TU ELECTRIC

Log # TXX-92318
File # 10010
Ref. 10CFR50.30(b)

SUBJECT: COMANCHE PEAK STEAM ELECTRIC STATION (CPSES)
DOCKET NOS. 50-445 AND 50-446
RESPONSE TO REQUEST FOR ADDITIONAL INFORMATION (RAI)
CONCERNING THE STARTUP TESTING PROGRAM

The following information is provided in response to the NRC RAI dated June 22, 1992, concerning the CPSES startup testing program.

Figure 14.2-3 PREOPERATIONAL TEST SCHEDULE

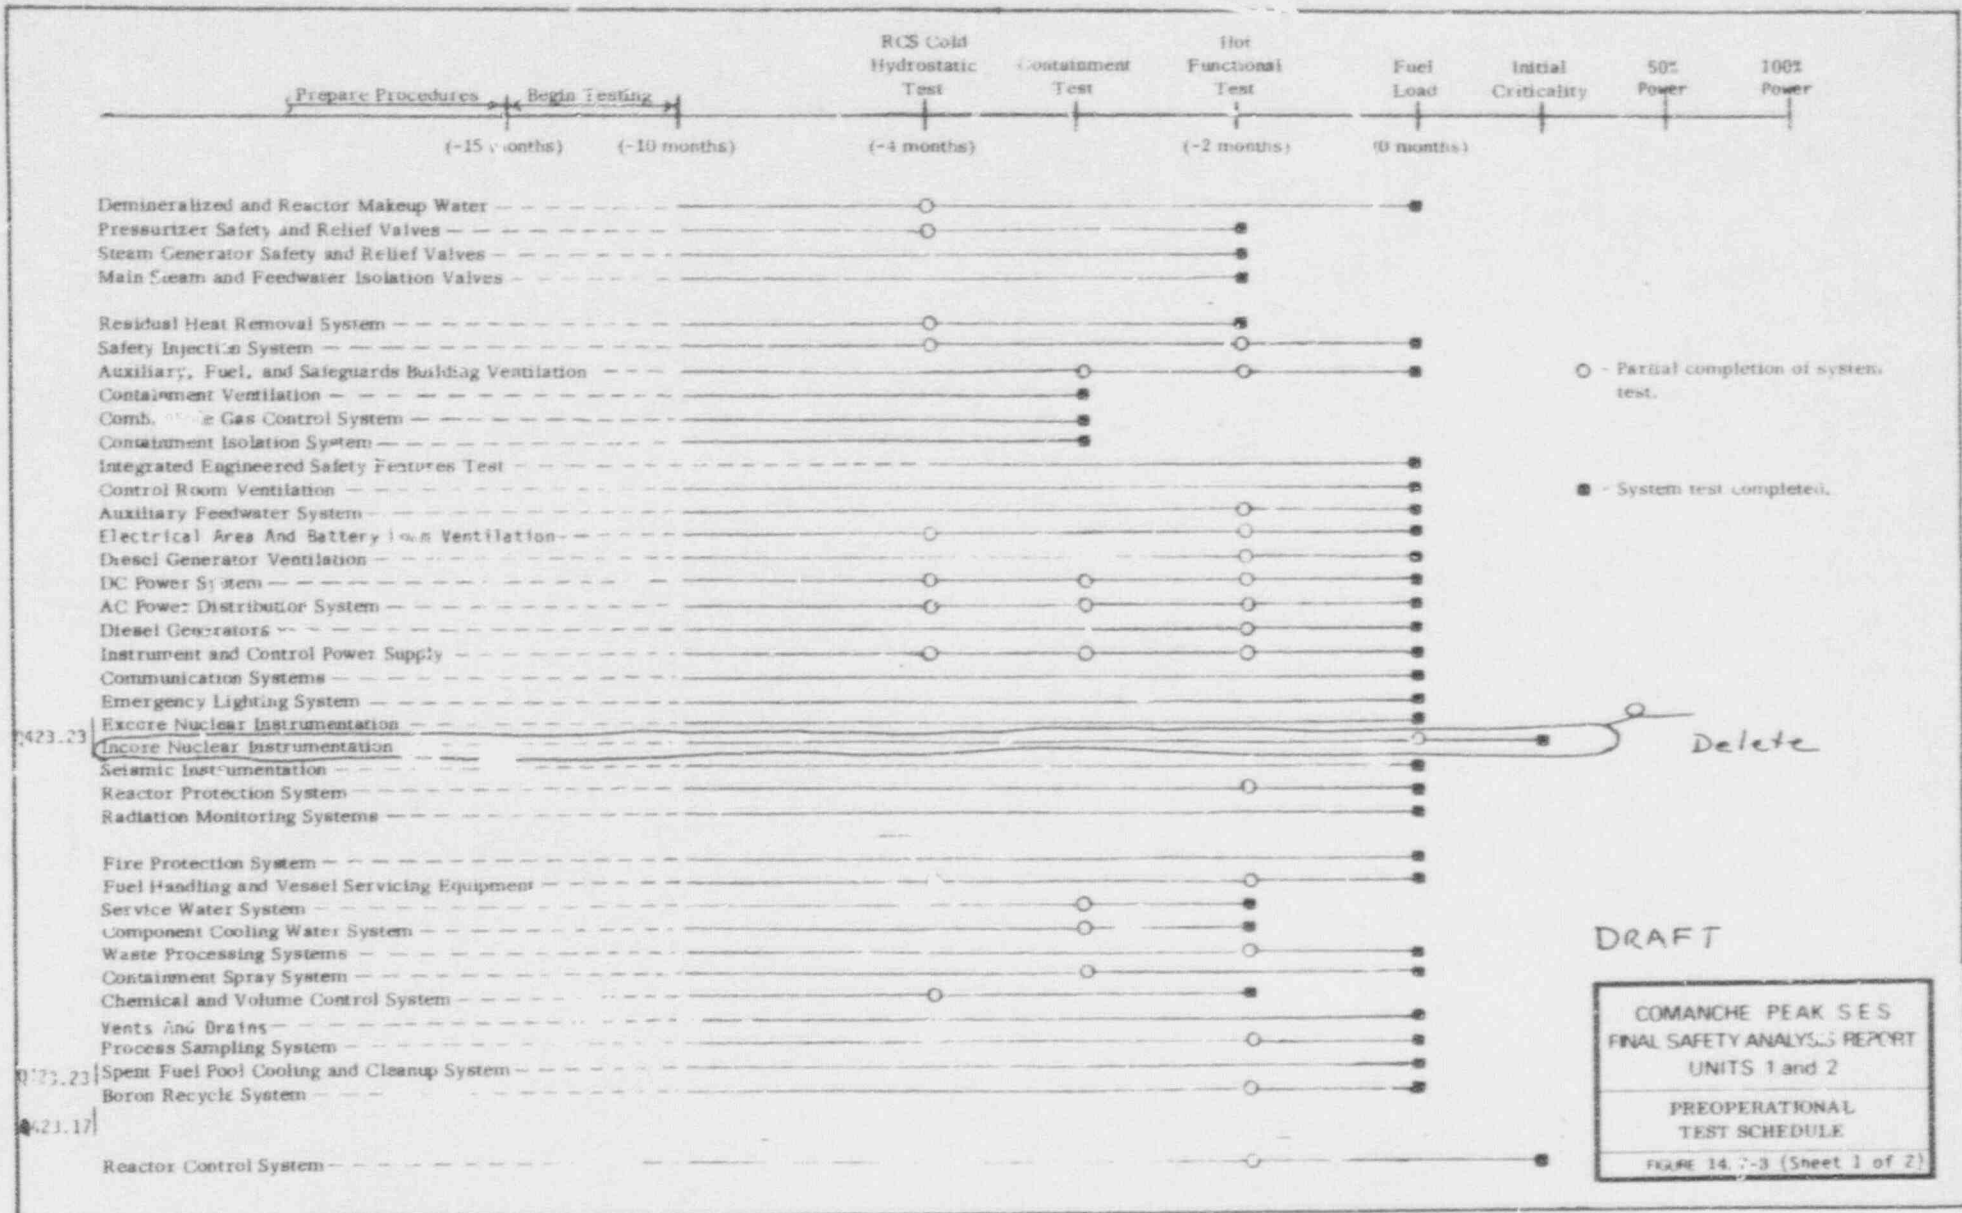
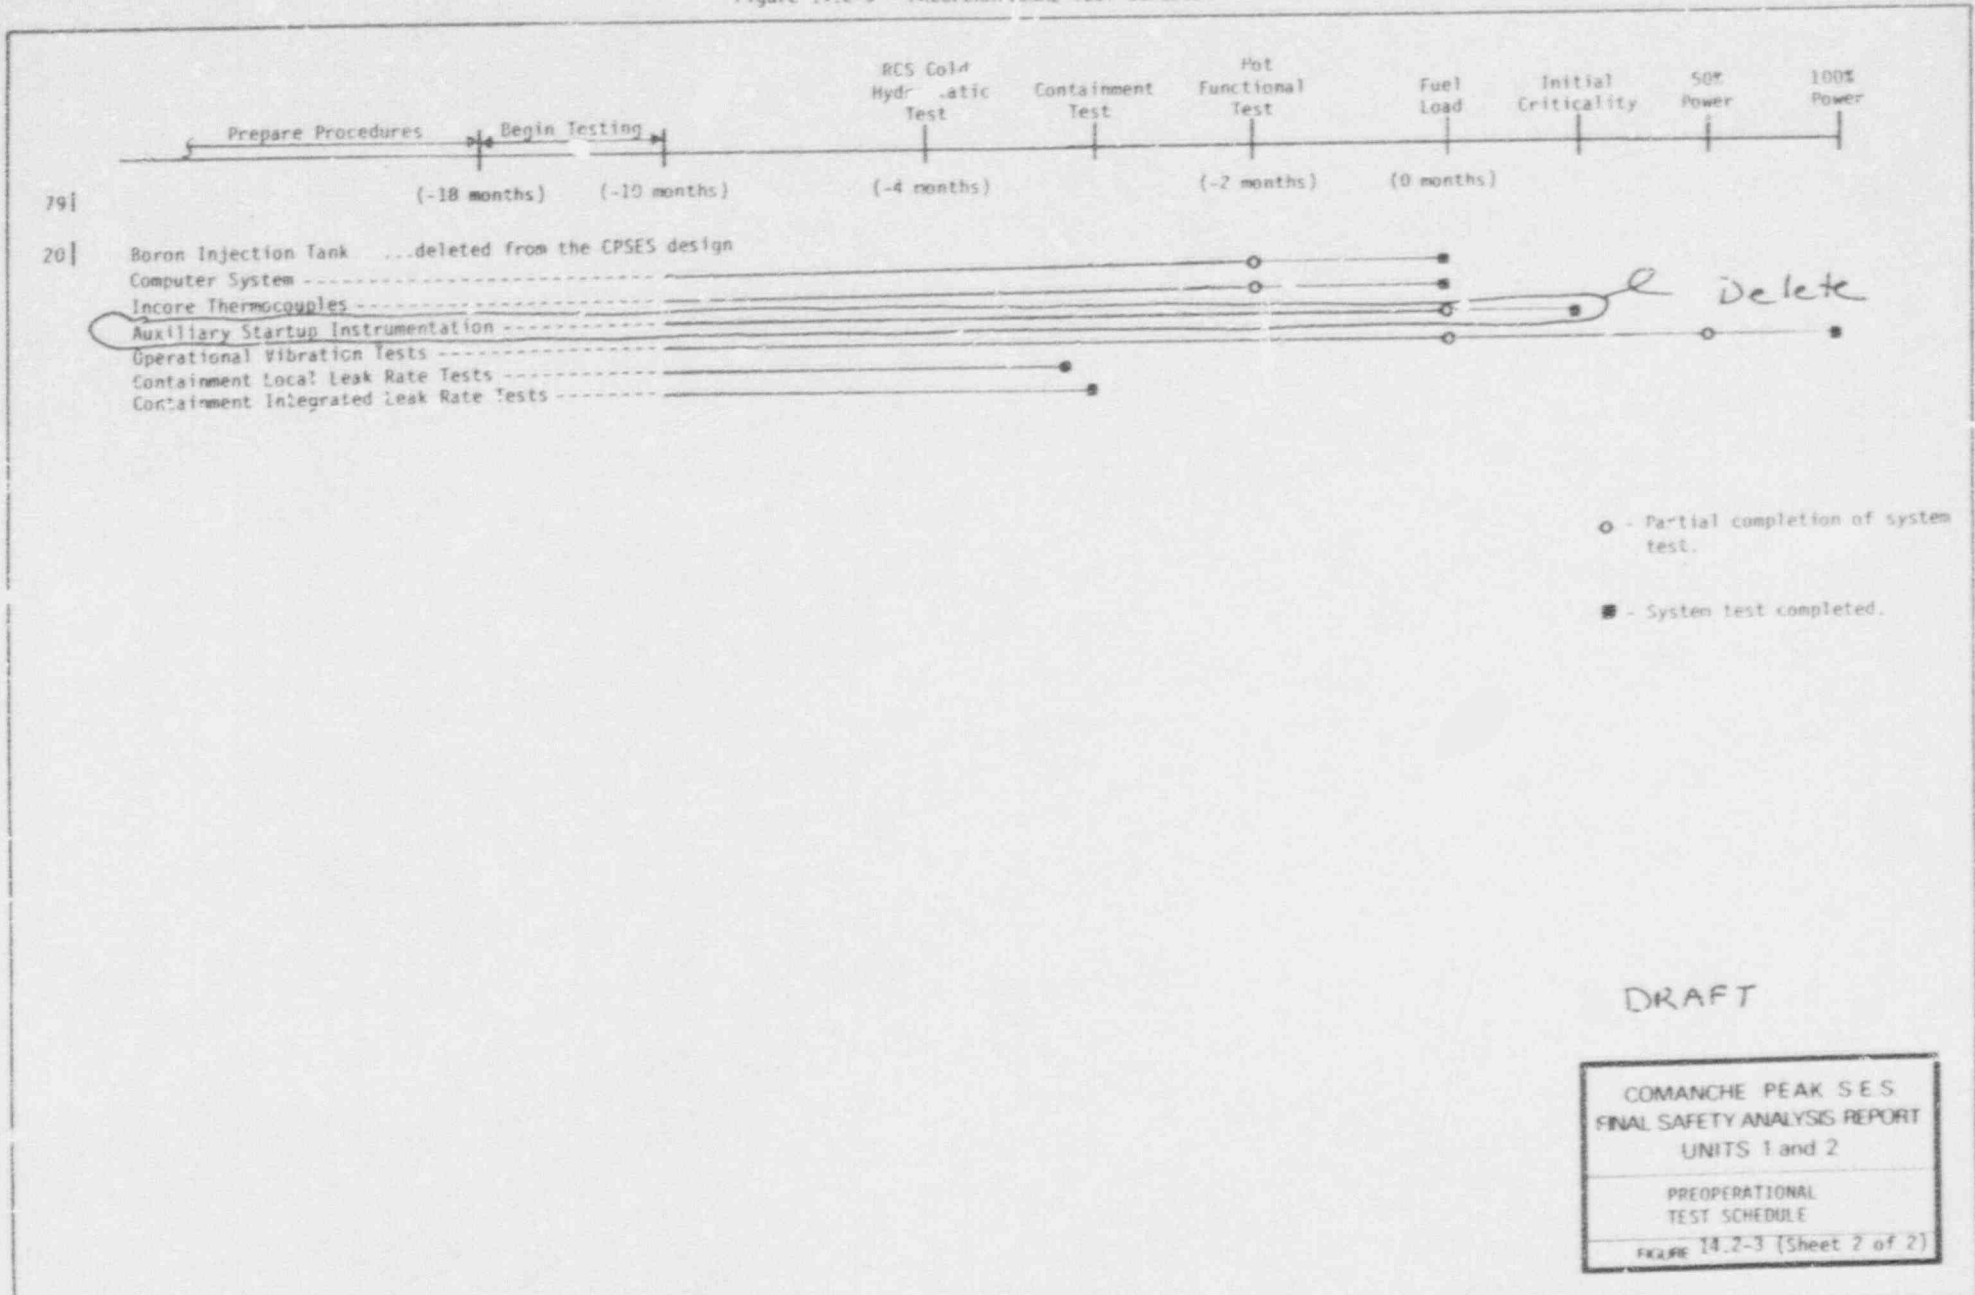
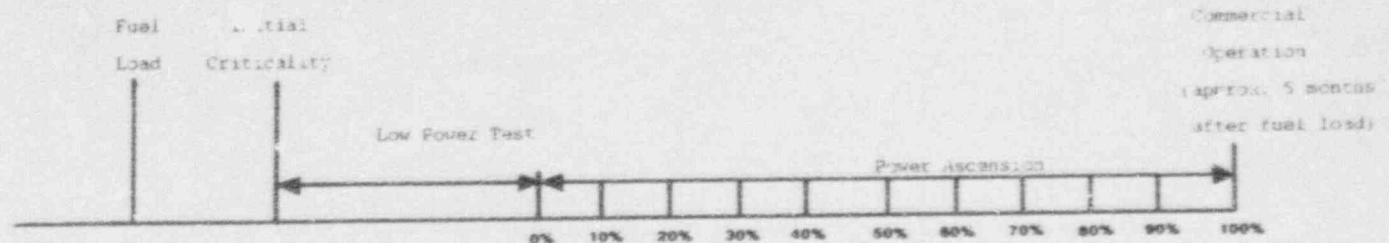
The response to Q423.2 describing preoperational testing was revised to delete test completion of the Nuclear Incore Instrumentation subsequent to fuel load and states that the Reactor Control System Test is the only preoperational test to be completed after fuel load (Amendment 78). The response to Q423.10 does not identify any additional preoperational tests intended to be completed after initial fuel load. The response to Q423.23, Item 1 states that Figure 14.2-3 has been revised to correctly reflect the response to Q423.10. Figure 14.2-3 shows that the following additional preoperational tests will be completed after initial fuel load:

- * Incore Nuclear Instrumentation
- * Auxiliary Startup Instrumentation
- * Operational Vibration Tests

For each of these tests, either modify Figure 14.2-3 to show that these tests will be completed prior to fuel load, or modify the response to Q423.10 to: (1) state what portions of each test will be delayed until after fuel loading, (2) provide technical justification for delaying these portions, and (3) state when each test will be completed (key responses to operating modes defined in Technical Specifications or to power ascension test power levels defined in Chapter 14).

The descriptions of "Incore Nuclear Instrumentation" and "Auxiliary Startup Instrumentation" testing were relocated under the Initial Startup program and included in Table 14.2-3 in a previous FSAR amendment. Figures 14.2-3 and 14.2-4 were inadvertently not updated to reflect these changes at that time. Updated Figures 14.2-3 and 14.2-4 are attached. Also, see attached revised responses to Q423.2 and Q423.10 (pages 423-2, 3, 4 and 19) for requested information related to "Operational Vibration Test".

Figure 14.2-3 has been revised as follows:

- a. The Reactor Trip System has been deleted (refer to question 423.17 response)
- b. The Excore Nuclear Instrumentation, Spent Fuel Pool Cooling and Cleanup System tests shall be completed prior to fuel load.
- c. Reactor Control System test shall be completed after fuel load.
- d. The Incore Nuclear Instrumentation test has been moved to the initial startup phase.
- e. The Auxiliary Startup Instrumentation test has been moved to the initial startup phase.
